Re: SSD-80211463 for 164-172, 174-194 William Street WOOLLOOMOOLOO NSW 2011

Mixed use development with in-fill affordable housing, 164 – 194 William Street, Woolloomooloo

Bias and inaccuracies in View Impact Assessments

Figure 2 – Actual location of viewpoint 9 with markups included

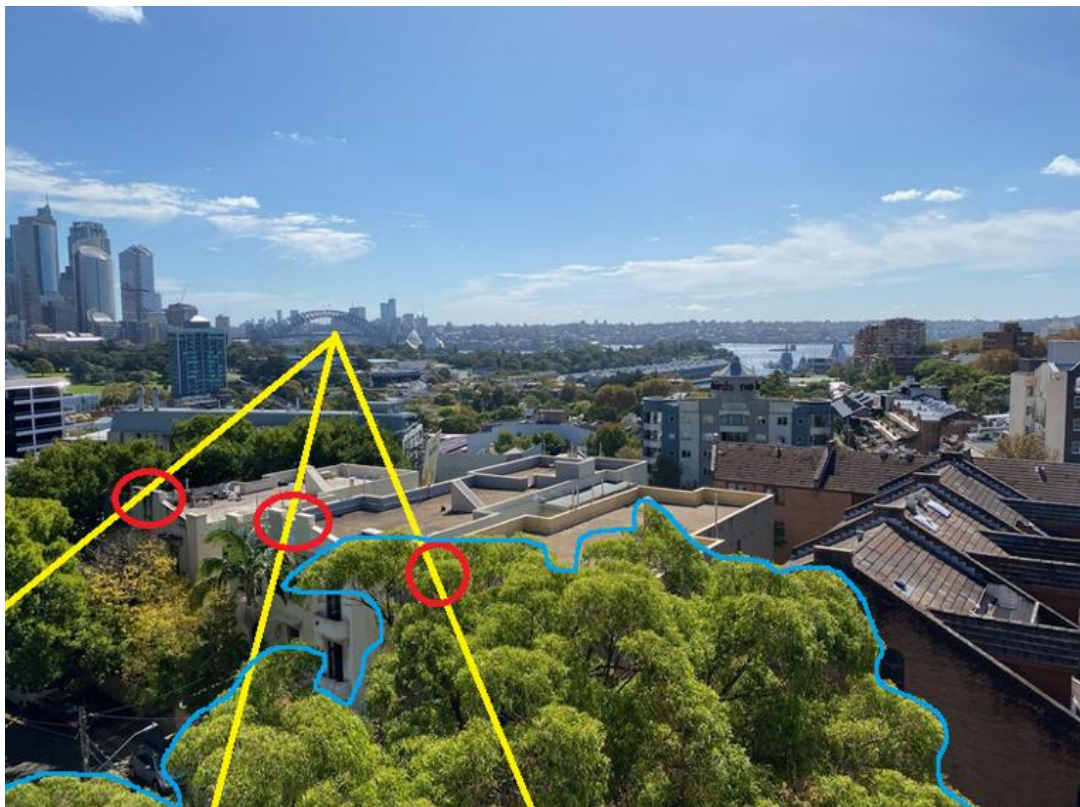
The following photo was taken by us in April 2023 using an iPhone camera, from the actual location of the balcony of Unit 22 on level 5 (7th storey equivalent). This unit is on the north-west corner on our level and the photo was taken standing on the balcony behind the balustrade. Markups have been overlaid for guidance:

The blue outline shows the large tree located at the front of our building. The yellow lines have been extrapolated through key points of the buildings across the road towards the Harbour Bridge to provide additional context regarding the balcony's true position in relation to its surroundings.

In the actual balcony position (Figure 2), the direct line of sight to the Harbour Bridge intersects the centre between the 2nd and 3rd yellow lines. In comparison, the developer’s photo (Figure 3) places this alignment well to the right.

Figure 5 - Viewpoint 9 according to Urbaine Designs with our markups

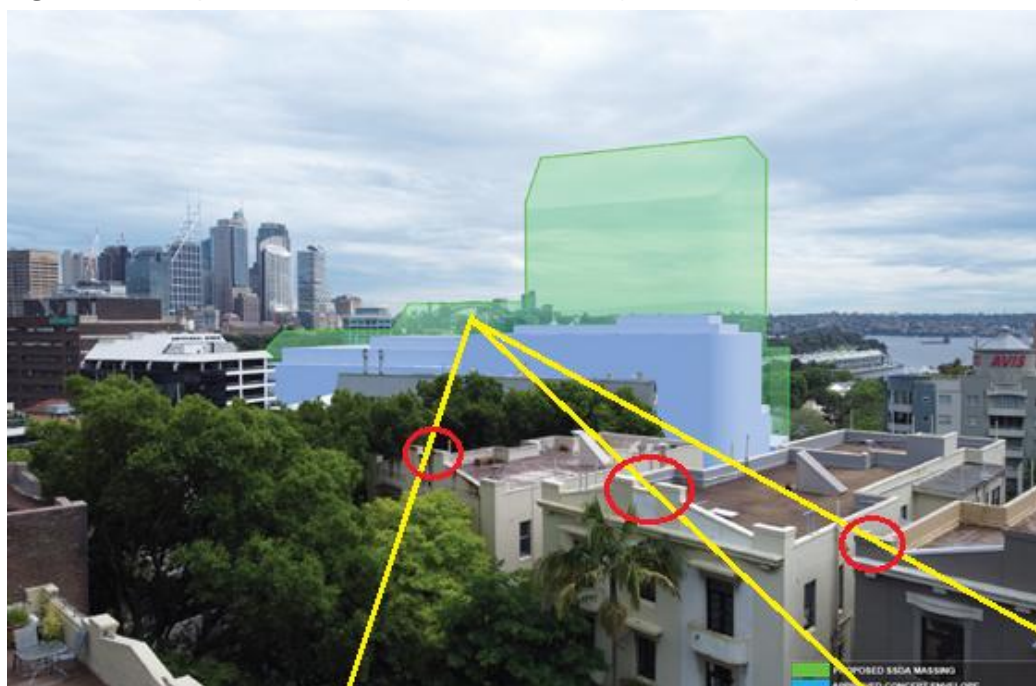
At level 5 (7th storey equivalent), the Harbour Bridge is now completely obscured due to the increase in height of the buildings step-down. Levels 6 and above, however, may still appear to retain visibility through the stepdown due to the exaggerated angle. While the significance of this inaccuracy may be debated, it remains important because it is both **misleading and creates an illusionary impression** of retained view for the north-west balconies and particularly given that there are two additional sets of north facing balconies extending further to the east.

Figure 6 – viewpoint 12 drone vantage point

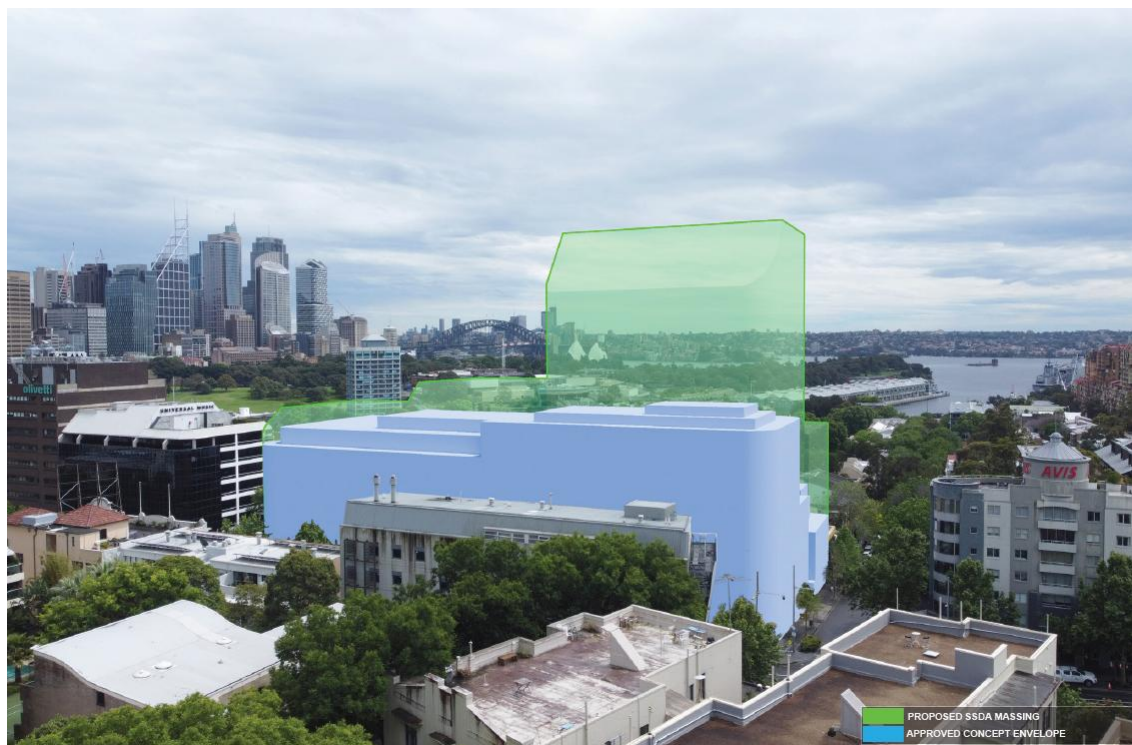
The actual balconies, along with the two additional sets of balconies to the east of the north-western balcony, are now likely to have the remaining iconic landmark (Harbour Bridge) partially or completely obscured. It is **deeply concerning** that even a penthouse apartment on level 9 (11th storey equivalent), positioned near the top of the Darlinghurst rise, would see the top of the proposed development protruding above the highest part of the city skyline!

Figures 11 – 18 – Various Urbaine Design photo snippets near building step down

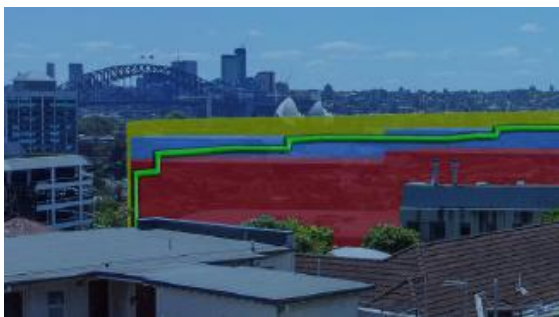
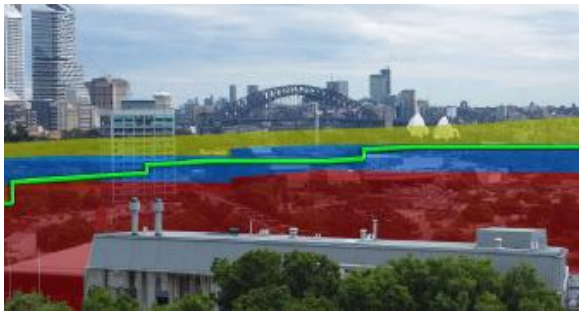
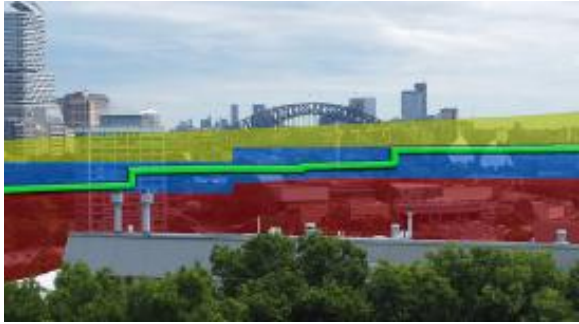
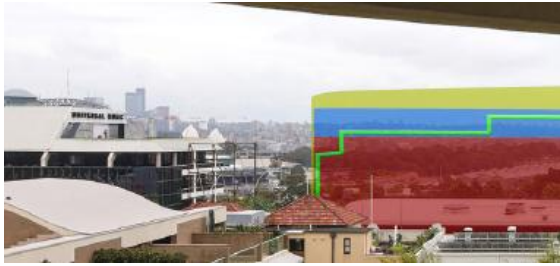
Several other vantage points in the *View Impact Assessment* appear to intentionally focus on retaining a view of key landmarks such as the Harbour Bridge, Opera House, or Fort Denison, near a step-down in the proposed building. However, these points of interest would be unlikely to be visible in the omitted properties.

One would conclude that **photos were biased** towards vantages favouring less severe view impacts for the benefit of the developer in securing approval. The same vantages are used in the new *View Impact Assessment*.

Figure 19 – New selected viewpoints for Urbaine Designs new View Impact Assessment

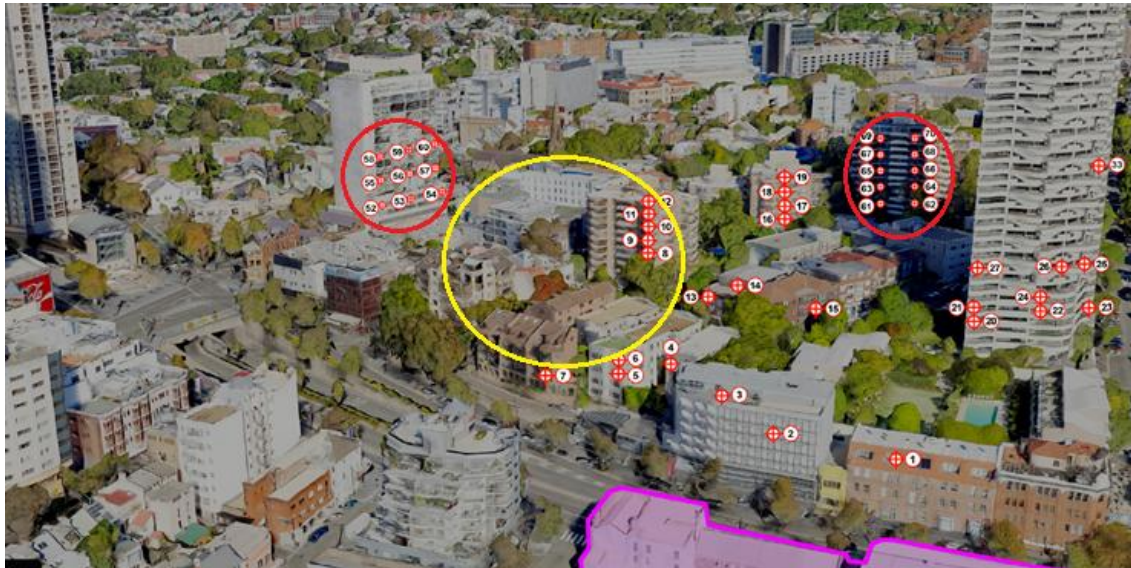
As illustrated below, new viewpoints have been added, as indicated by the red circles. However, buildings within the yellow circle, who are again arguably amongst the most impacted, remain under-represented. This includes Palisades North Tower as explained in earlier sections. The newly represented buildings are located on either side of the proposed development, where some partial views may still be available.

Figure 24 – View impact from proposed building envelope on unit 24

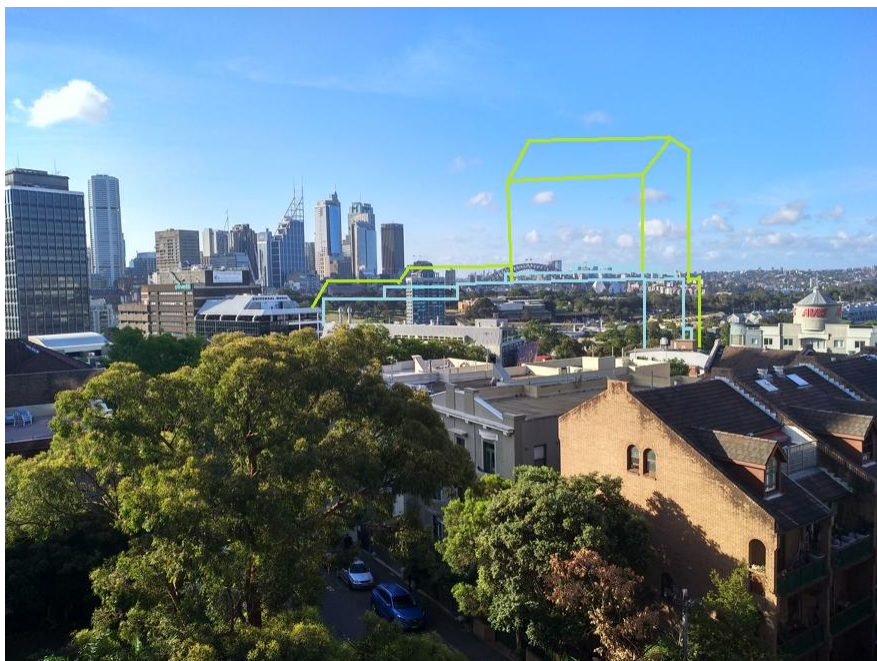
The next is based on the photo from Figure 22 and includes an outline estimation of the form of the newly proposed building envelope (in blue) compared to the approved concept (in green). When comparing this with the developer's representation of unit 22 in *Figure 6 - viewpoint 12 drone vantage point*, which is on the same level as ours, it demonstrates a reasonable accuracy of replication, with the building slightly rotated to reflect the differing angle from our unit.

From this, it can be seen that the approved concept envelope allowed a partial view of the upper arch of the Harbour Bridge, whereas the new envelope blocks it entirely.
